Building Permit Application

Permit No.: B17000055

MEMORANDUM

RE: Walnut Creek Lot 124
5049 Lindera Ct.
Ellicott City, 21042
"Potential Basement Bedroom"

1 BASEMENT FLOOR PLAN
SCALE: 1/4" = 1'-0"

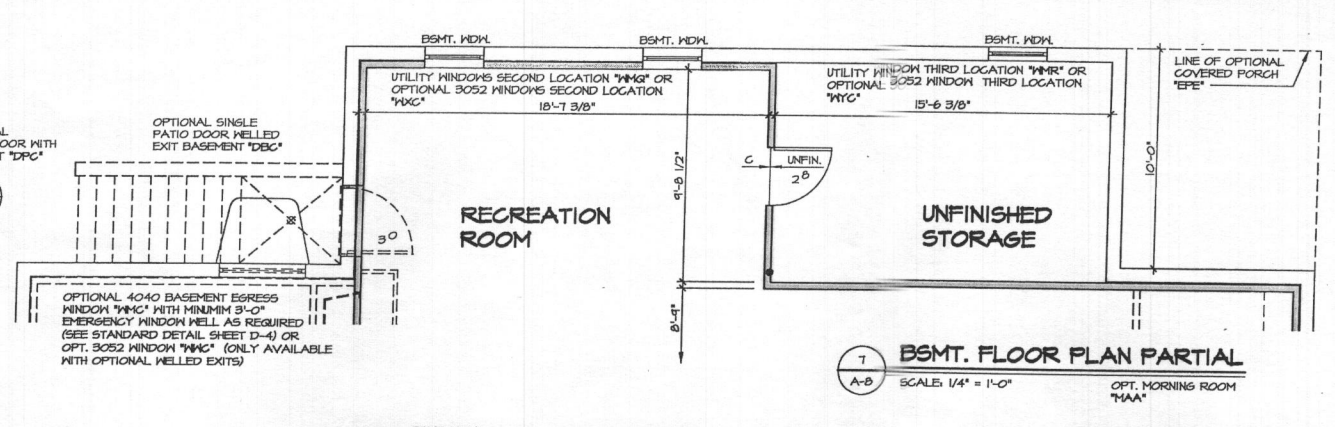
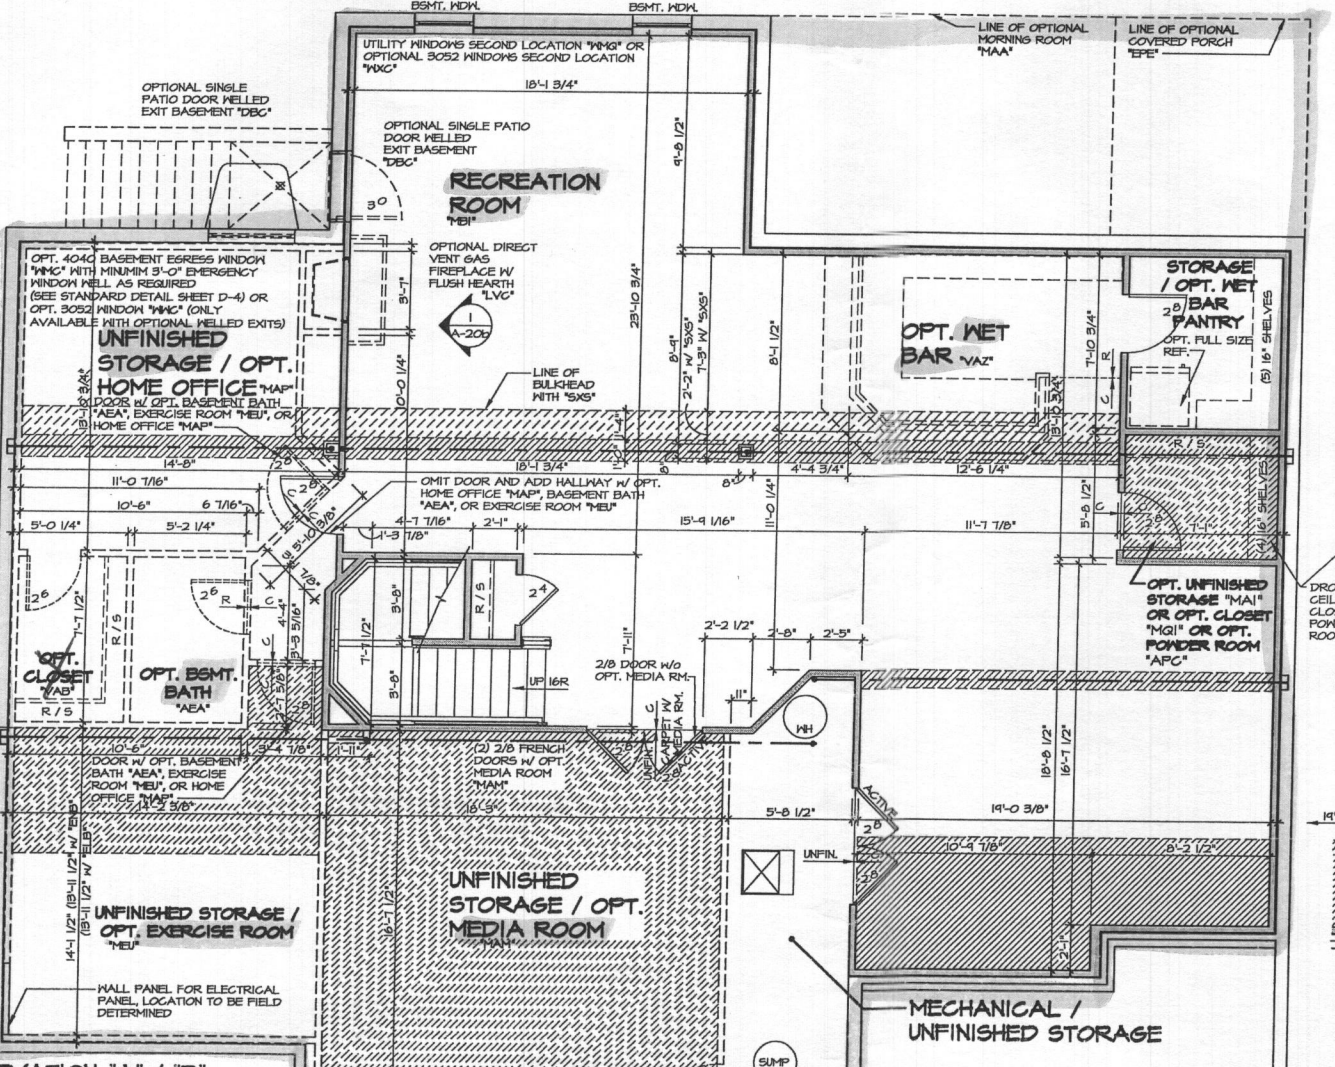
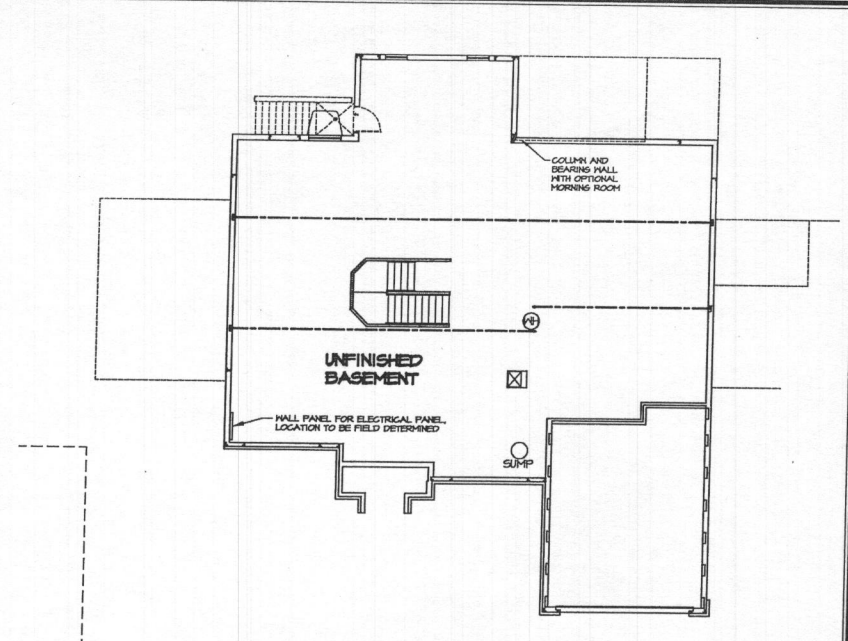
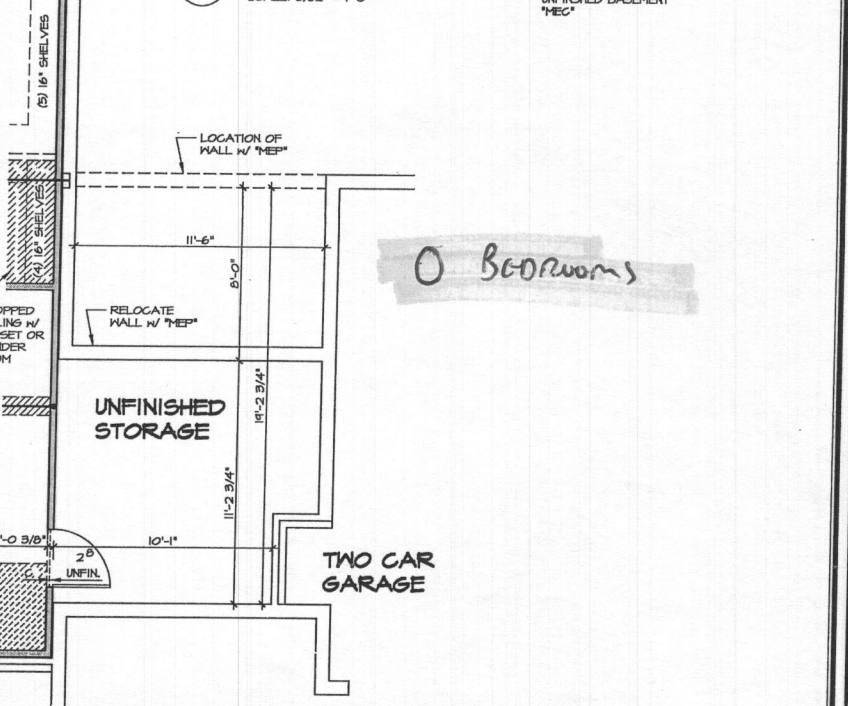
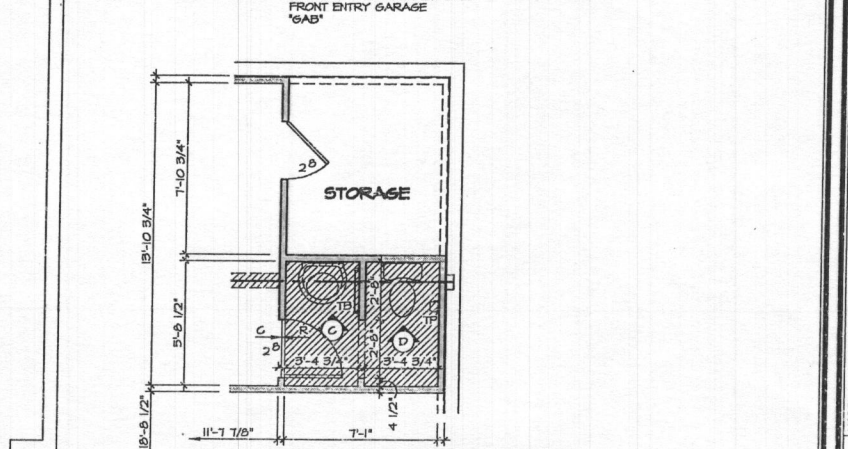
I have reviewed the floor plans in support of Building Permit **B17000055** for a new home at **5049 Lindera Ct.** and was informed as per our email conversation that the full bath in the finished basement would be finished. Please note that the unfinished storage/opt. home office upon completion to living space will be considered a bedroom in conjunction with the finished full bath. This would bring the total bedroom count to six in a shared septic system which as a five bedroom per lot limitation. Any future building permit converting the unfinished storage/opt. home office to living space will be denied by the Health Dept. if the bedroom count exceeds five. Alterations to existing bedrooms can be made in order to stay under the five bedroom limitation.

Taylor,
Can you confirm for me whether or not the storage areas for these basements will be finished? I forgot to ask in my last email.

I am reviewing the building permits for both 5013 Lindera Ct. (B16005320) and 5049 Lindera Ct. (B17000055). Is the full bath in the finished basement going to be a finished full bath or roughed in?

For 5049 Lindera Ct (Lot 124) the Exercise Room and Media Room on the front side of the basement will be finished, but not the Home Office. The Home Office is to remain a storage area.

Both of these homes will have the finished basement baths.

Approved for 5 BRs
B17000055 1/17/17
RAE
